**Albemarle County Planning Commission
Work Session
Final Minutes October 25, 2022**

Work Session

Mr. Cameron Langille stated that today their work session was for a potential zoning map amendment application and some questions that staff and the applicant had for the Commission about some of the comprehensive plan recommendations. He said the property in question was Tax Map Parcel 61W-02-0A-2, 3.227 acres located on the east side of Route 29. He said that it was currently zoned C1 commercial and was located on the boundary between Albemarle County and the City of Charlottesville. He stated that there was a wide range of uses that surrounded this parcel, most of them nonresidential, along with some retirement and assisted living facilities to the northeast. He said this parcel was the former site of the Cville Oriental Grocery Store, and at the rear of the property was an existing business that did automobile service work.

LEVEL 1 FLOOR PLAN

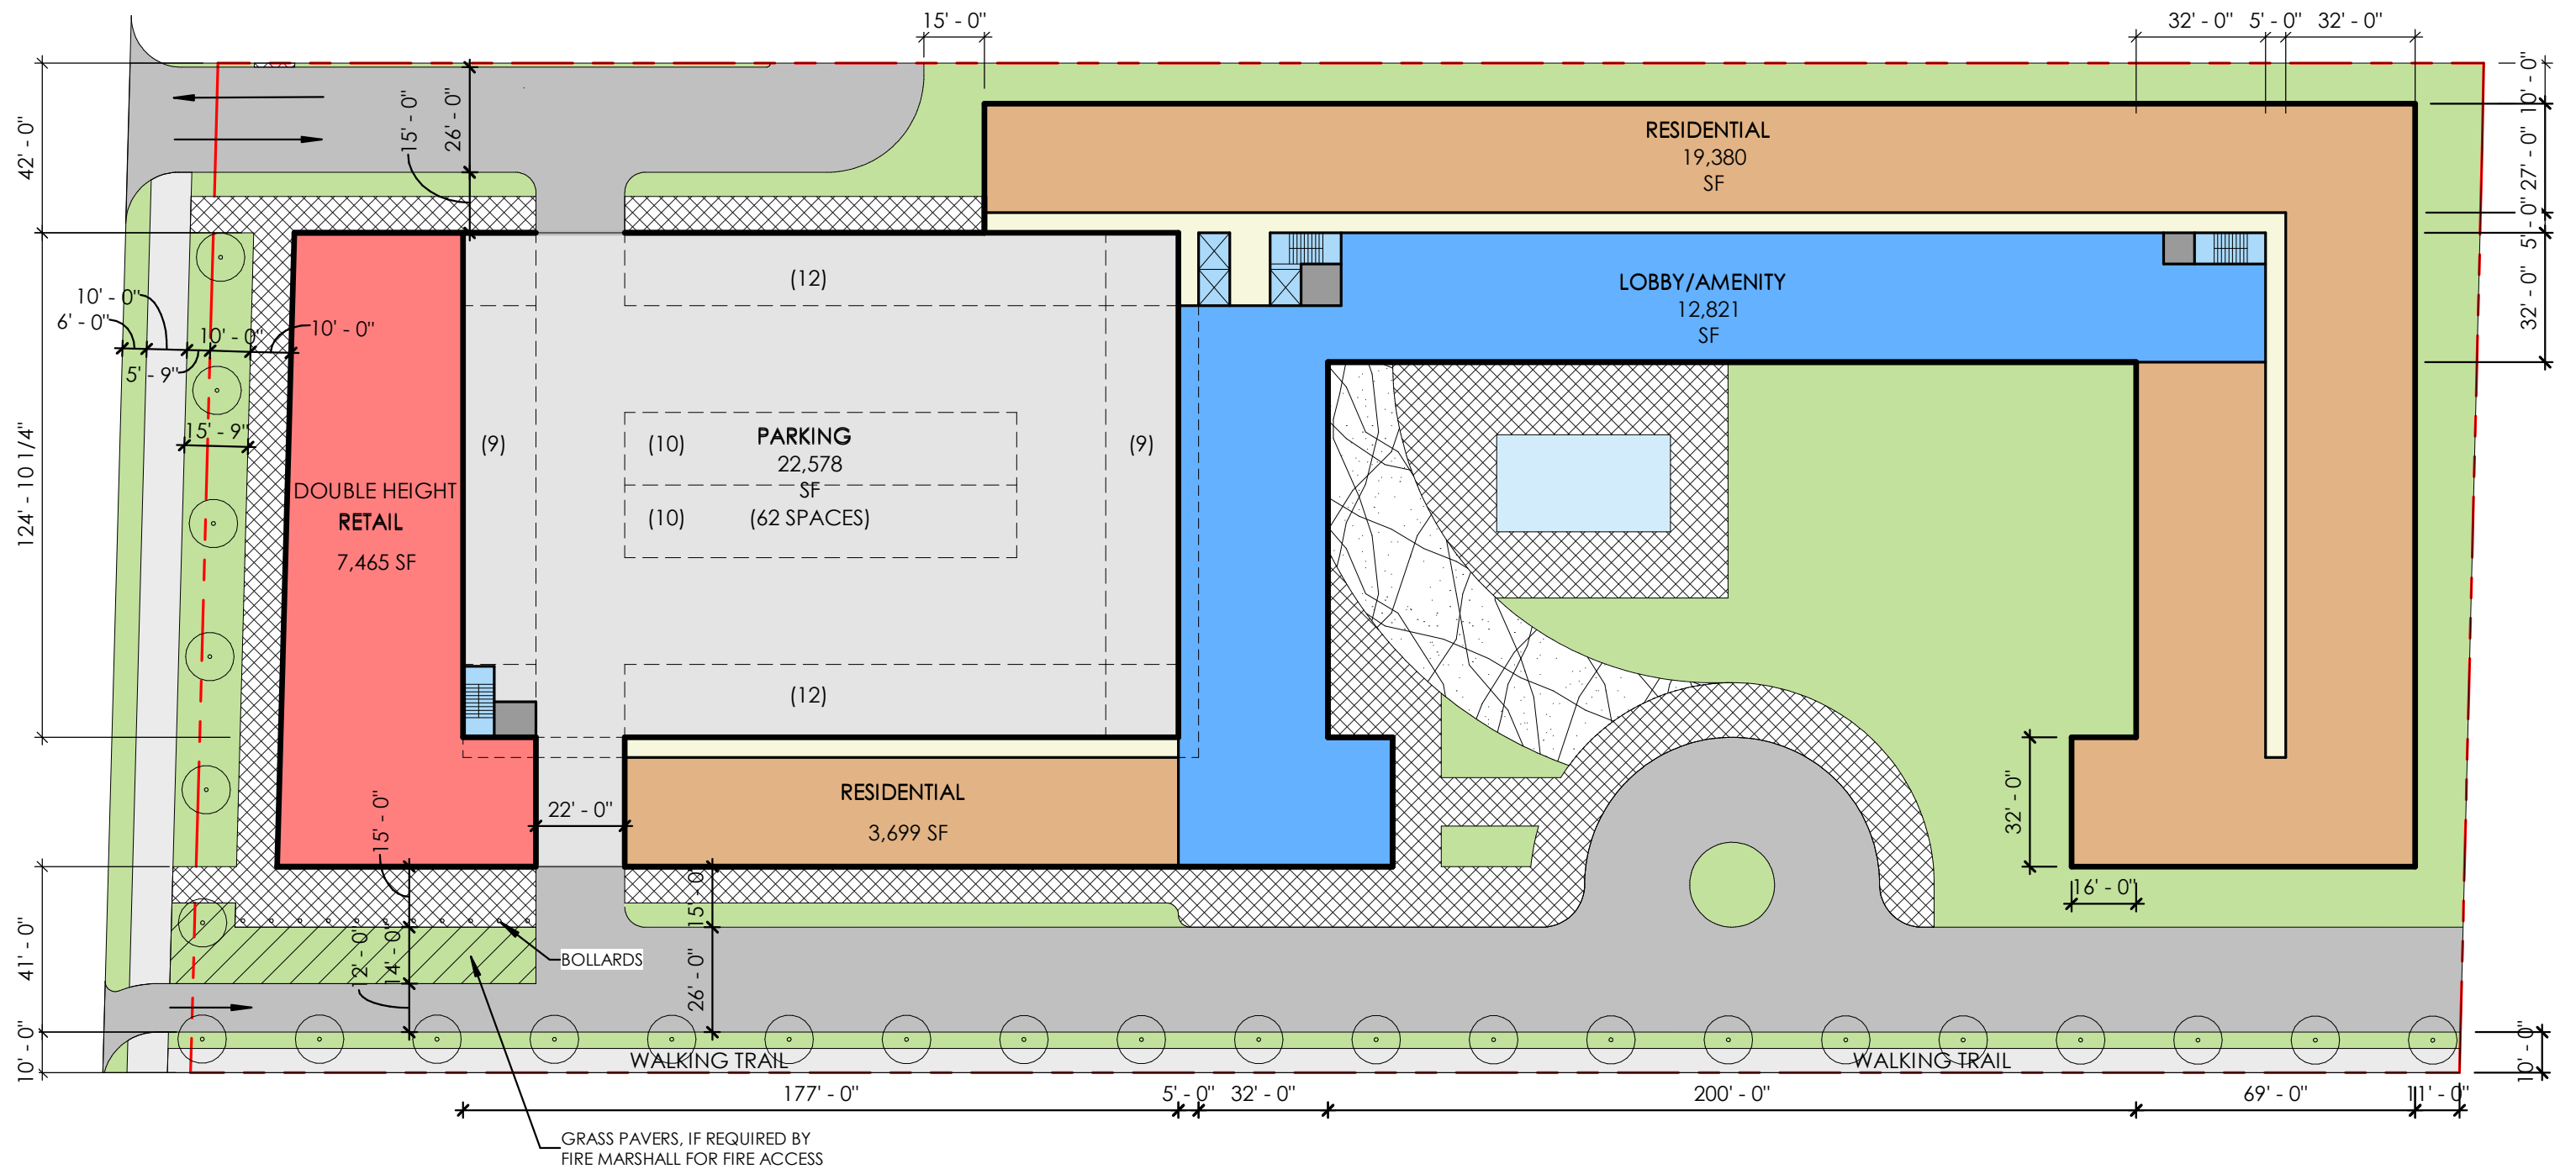
Mr. Deeds said that was correct. He said that most of the first floor would be parking dedicated to the retail on the first floor, as outlined in their plans. He said essentially for security reasons, they would FOB (what is FOB) off the upper floors so that no one would get into the apartments.

Mr. Deeds noted that the light blue would be amenity space such as a lobby, sports court, or pool.
